COLLISION REPAIR INFORMATION

TITLE: QUARTER PANEL SECTIONING
SECTION: EXTERIOR BULLETIN # 183
MODELS: 2013- SCION FR-S
DATE: DECEMBER 2012

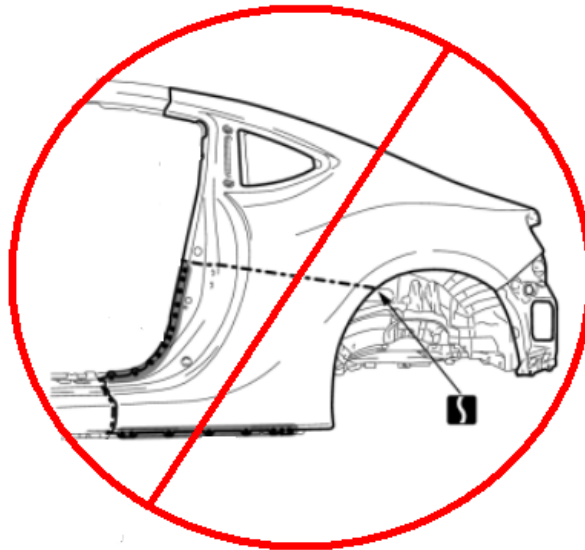
The 'Quarter Panel Sectioning' procedure shown below referred to as "Cut-P" "Small Section", **has been determined to be an unacceptable repair procedure** by the conditions provided below.

NOTE: The P-Cut Small Section replacement procedure may lead to one or more of the following unacceptable conditions:

- Excessive panel warping
- Extensive corrosive hot-spots from butt welding
- Excessive use of body filler materials
- Reduced repair quality leading to a detectable repair
